Access Compliance Report

Public Rights-of-Way

(Curb Ramps)

Intersection ID: 11698	Main Street: S CEDAR ST	Cross Street: W 4TH ST	Location: SW
ADA ID: E8C992AC9B22	Ramp Type: PerpDiag	Initial Pass/Fail: Pass	Overall Compliance: No
Codes/Mitigation Info/Possible Solution		Field Measurements/Component Compliance

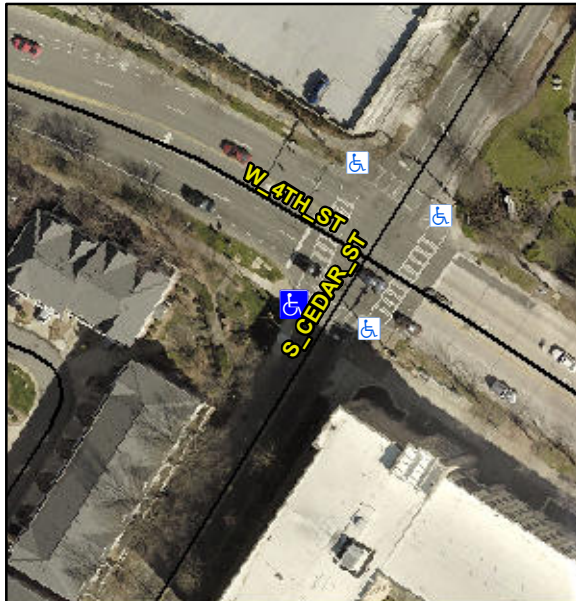
Not Found, R304.5.3, R304.2.1, R304.2.2-Perp, R304.3.2-Para, R305.1.4, R305.2

Compliance	Description	Data	Compliance	Description	Data
N/A	Ramp Length (in)	70.0	Yes	Ramp Slope (%)	5.4
Yes	Ramp Width (in)	48.0	No	Ramp XSlope (%)	2.5
N/A	Flare Type LT	Sloped	N/A	Flare Type RT	N/A
N/A	Flare Slope LT (%)	6.3	Yes	Flare Slope RT (%)	9.4
N/A	Flare Traversable LT?	Yes	N/A	Flare Traversable RT?	Yes
No	Landing Length (in)	N/A	Yes	DWS Provided?	Yes
No	Landing Width (in)	N/A	Yes	DWS Contrast?	Yes
No	Landing Slope (%)	N/A	Yes	DWS Length (in)	24.0
No	Landing X Slope (%)	N/A	No	DWS Full Width?	No
N/A	Landing Curb? (Y/N)	No	No	DWS Offset (in)	7.5
N/A	Shared Landing?	N/A			
Yes	Gutter Ponding?	No	Yes	Gutter Slope (%)	3.9
Yes	Gutter Lip Ht (in)	0.0	Yes	Gutter X Slope (%)	1.7
N/A	Painted X Walk1?	Yes	N/A	Painted X Walk2?	Yes
	X Walk 1 Direction	To SE		X Walk 2 Direction	To NE
N/A	X Walk 1 Width (in)	111.0	N/A	X Walk 2 Width (in)	120.0
	X Walk 1 Slope (%)	0.4		X Walk 2 Slope (%)	1.4
	X Walk 1 X Slope (%)	0.2		X Walk 2 X Slope (%)	1.8

Yes	Ramp inside XWalk1?	Yes	Yes	Ramp inside XWalk2?	Yes
	Road Slope (%)	0.2	N/A	Clear Space?	Yes
	Road X Slope (%)	4.7	Yes	Clear Space to XWalk (in)	84.0
Yes	Any Obstructions?	No	Yes	Storm Grate/Utility Hazard?	No
	Obstruction Type			Storm Grate/Utility Type	
		N/A			N/A
			Yes	Surface Condition? (G/P)	Good

Remove & Replace Curb Ramp With Two New Directional Ramps or Equivalent.
